Re: Comments on Proposed Permit No: MTX000274, R Bar N Estates Subdivision

To: Guy Alsentzer, Executive Director, Upper Missouri Waterkeepers  
From: Betty Stroock, Geologist  
Date: February 9, 2022  
Re: Hydro-Geologic Evaluation of Proposed Groundwater Discharge Permit for Proposed R-Bar-N Estates Subdivision, Gallatin County, Montana

## GLWQD Map of Groundwater Contours, Subdivisions, and Groundwater Data Points Surrounding the Project Area

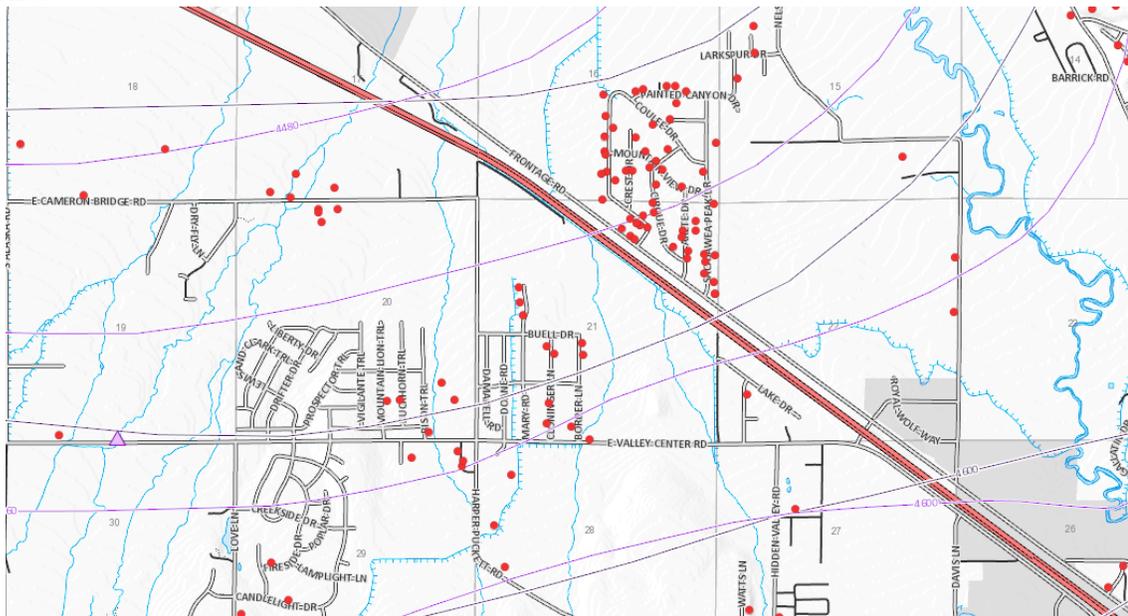
DEQ should first identify and recognize the cumulative nature of nutrient pollution and the significance of adding a substantial new nutrient pollution input of poorly treated septic to a water resources system already stressed by nutrient pollution. In particular we direct DEQ’s attention to aggregated well data accessible on the Gallatin Local Water Quality District’s interactive web portal, and cited to by Waterkeeper’s expert, indicating the prolific sprawl development surrounding the proposed permit and datapoints showing nitrate concentrations increasing at and downgradient of the project area.

DEQ should assess the cumulative and synergistic impacts of the proposed discharge in connection with the other existing and known nutrient pollution sources discharging to the same watershed. This is particularly important given, as demonstrated by the Hackett, English, and Schaeffer studies cited herein, and Waterkeeper's expert report, that ground and surface water are interconnected in and downgradient of the project area, and that water gains and losses from surface and ground waters throughout the Gallatin Valley, including the Bozeman and Belgrade alluvial fans proximate to the project area. The fact that downgradient surface waters are nutrient-impaired heightens the urgency to perform these analyses and reconsider the propriety of the proposed permit and its effluent limits.
